Detailed responses to Reviewer #3

This paper evaluates the use of low-cost non-dispersive infrared (NDIR) CO₂ sensors for long-term atmospheric monitoring in rural agricultural environments. The authors developed a data-processing framework that corrects errors caused by automatic baseline correction and environmental influences, particularly temperature and pressure, improving the agreement with reference-grade instruments. The study is important as it applies sensor correction and QA/QC procedures to non-urban applications. However, it is unclear how some of the corrections were derived, as well as which sensor data are presented, that make this manuscript not publishable in its current form. I recommend review once the points below are addressed.

Figure 3. Pressure effect and correction for the LC AG-S8 CO₂ sensors. (a) Pressure dependence, expressed as P/P_0 and $\chi_{CO_2}^{LC}/\chi_{CO_2}^{refr}$, at the urban site (15 January–14 February 2025). (b) Uncorrected and pressure-corrected sensor data compared with the reference.

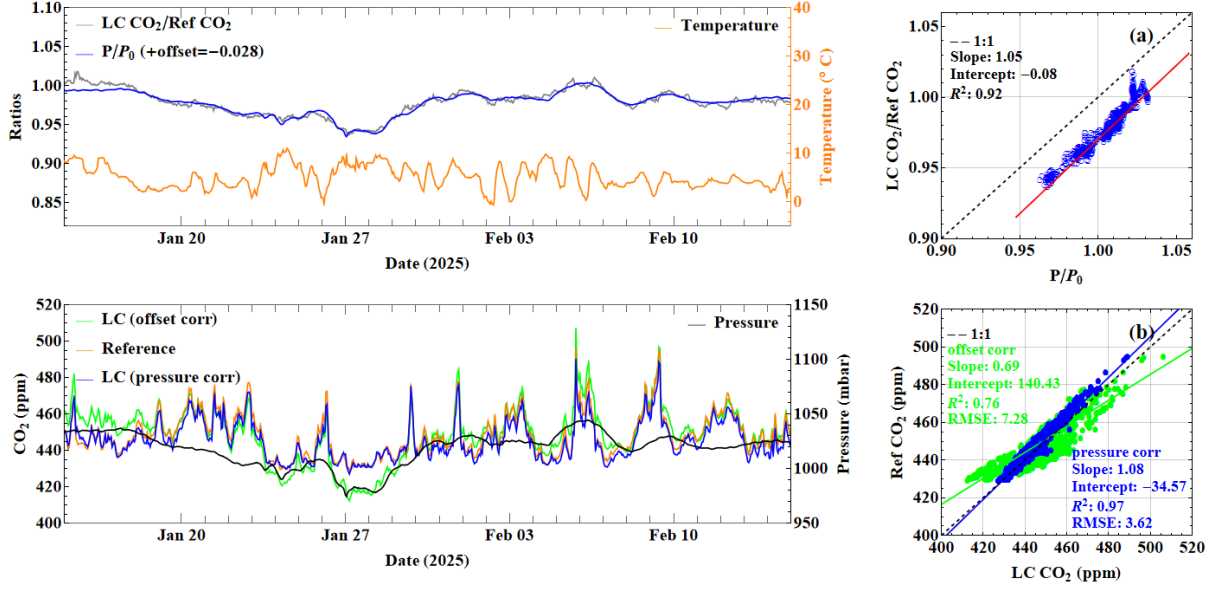
1) The derivation of temperature and pressure corrections are one of (if not *the*) main results of this work. However these are just presented in Section 2.4.2 as Equations (3) to (6). No detail is provided on how the coefficients in these equations were determined, how the authors came to decision of applying linear corrections in some cases, exponential corrections in others. It should be made clear to the reader how these were derived. This section should be significantly expanded to allow readers and sensor users to perform the same corrections.

Additional subsections 2.4.2.1 and 2.4.2.2 are now included to address these comments as detailed below.

A linear relationship was observed between the LC-to-reference CO₂ ratio and P/P_0 , with the regression describing the pressure-dependent correction factor. Figure 3(a) shows the relationship between the LC/reference CO₂ ratio, P/P_0 , and ambient temperature. The fitted expression (K in Figure 3 (a)) is analogous to the compensation coefficient described by Gaynullin et al. (2023). The pressure-corrected CO₂ mixing ratios, $\chi_{CO_2}^{reference}$, is therefore defined as

Figure 3(b) shows the comparison of the input CO₂ and pressure-corrected CO₂. As the temperature remained relatively low (<10 °C), with limited diurnal variability, pressure was identified as the environmental parameter most strongly associated with the observed the LC/reference CO₂ ratio variability, as indicated by the strong correlation in Figure 3(a). The correction approach yields a compensation expression that depends on both pressure and CO₂ mixing ratios, as it is derived empirically from real-world measurements in which the CO₂ mixing ratio varies with pressure. Applying the pressure correction substantially improved the agreement, with R² increasing from 0.69 to 0.97 and the RMSE decreasing from 7.3 to 3.6 ppm, Figure 3 (b). Analysis of the residual dependence of the uncorrected CO₂ reading with the pressure for the analysis shows the error associated to approximately 0.5 ppm mbar⁻¹ about five times that reported by Müller et al., 2020.

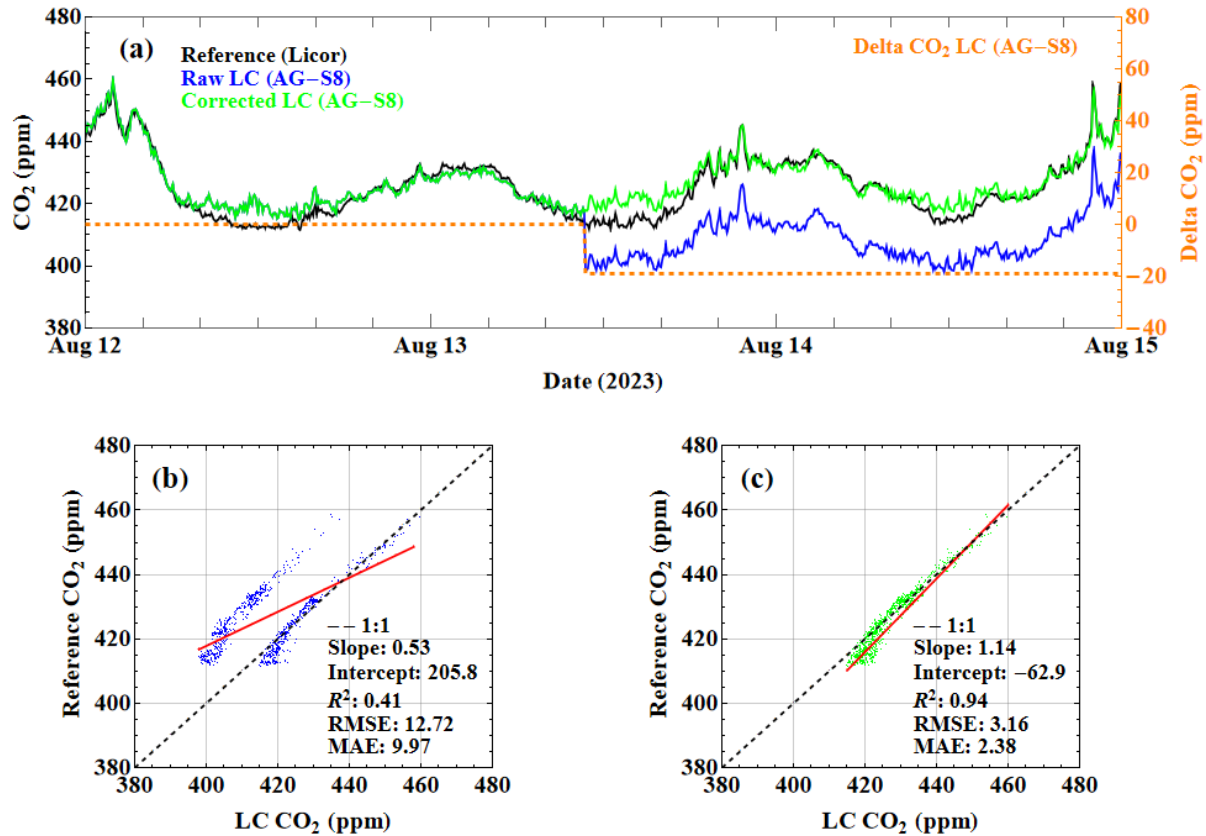
Line 255: similar to the point above, no detail is provided on how the ABC correction is derived and applied to the data. The authors do not describe what ABC is and the issues associated with it, but I could not find anywhere in the text describing how the authors correct for obvious step changes in the raw sensor data introduced by ABC.

Line 253: It would be useful to point the reader to where exactly in Figure 2 they should be looking at. Is it around 12:00 on Sept 20th in panel a? Lines 278-282: this section was very confusing. The author should state that which metrics being mentioned here are from the application of the full correction protocol, and which ones from the linear scaling. Figures 3, 4, 5, 7, 8, S1 and S2: are data from a single sensor system? Do similar plots for every sensor system deployed exist? It would be useful to show data from all sensors in each time series, like the authors have done in Fig 9. The same applies to Taylor's diagrams: are these metrics from just one sensor system? Or an average of the performance of the many systems tested and/or deployed?

A new subsection 2.4.1.1 is now included to address this as detailed below

Step changes were observed only to a limited extent and occurred in one device (AirGradient LC-S8) deployed at the rural site. Figure 2 shows an example of the step-correction procedure for this instrument.

L253 has been updated to reflect the revised analysis (2.4.4.1) included to describe the step correction approach.

Figure S4. Comparison of paired LC Magic-K33 units with the reference instrument during urban and rural deployments. (a, b) temperature, (c, d), RH, (e, f) CO₂ and (g, h) CO₂ time series at the urban (7-18 December 2022) and rural (20 December 2022-22 January 2023) sites, respectively.

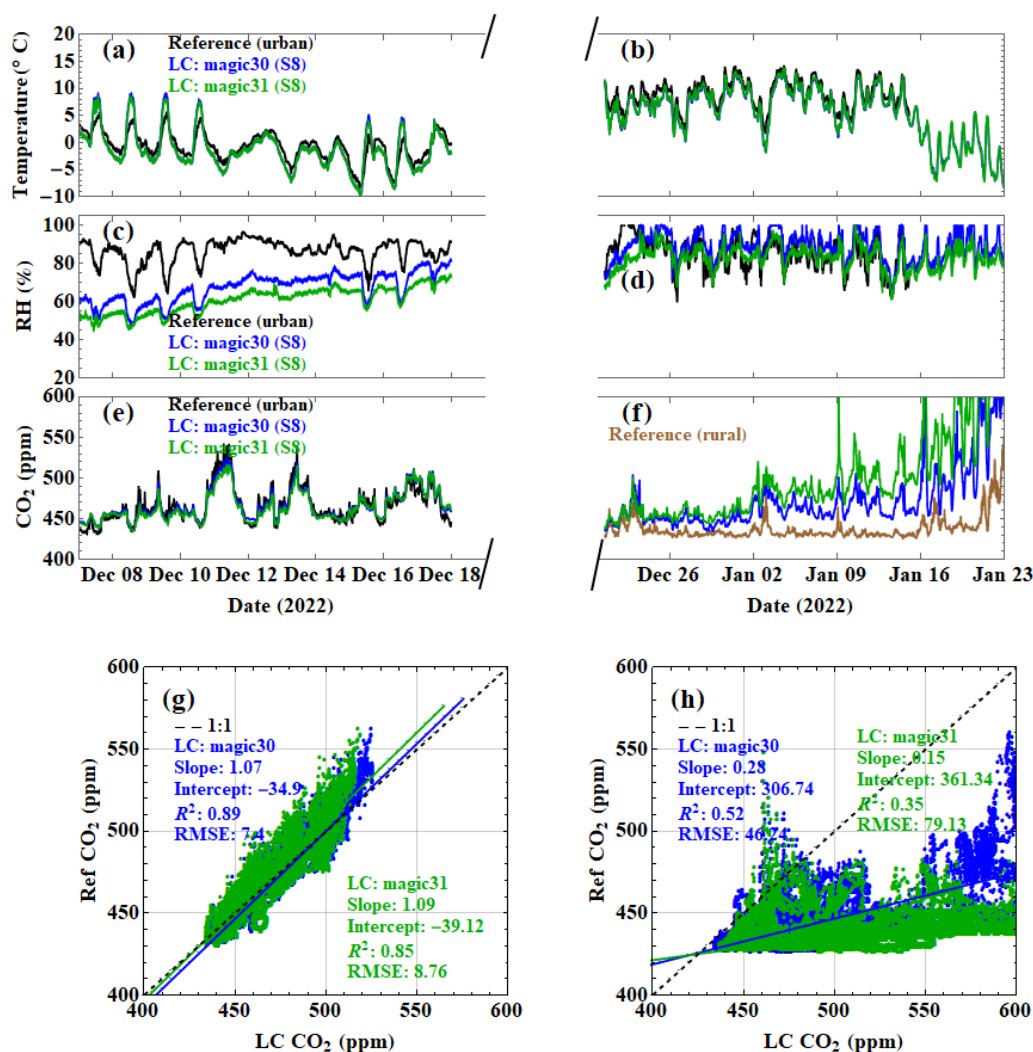
6) Section 3.5: why are the internal RH readings from the two Magic Boxes in Fig 10 very different from the reference ambient RH, whilst they seem to agree much better with the reference value in Fig 11? Is this just an effect of temperature? If so, it would help to show the air temperature too. The reference ambient RH at the two sites are very similar (slightly higher at the rural site, but similar range), so it is difficult to understand why the agreement with the internal readings is so different.

This figure has been revised to include temperature and moved to the Supplementary Information (Fig. S4). The following statements have been included in section 3.5 to explain the observations.

“Apart from small daytime differences of approximately 5 °C observed at the urban site, the internal temperature was comparable to the ambient reference temperature during this

period (Fig. S4 a). In contrast, the lower relative humidity measured inside the LC Magic boxes indicates substantially drier conditions relative to the ambient environment.”
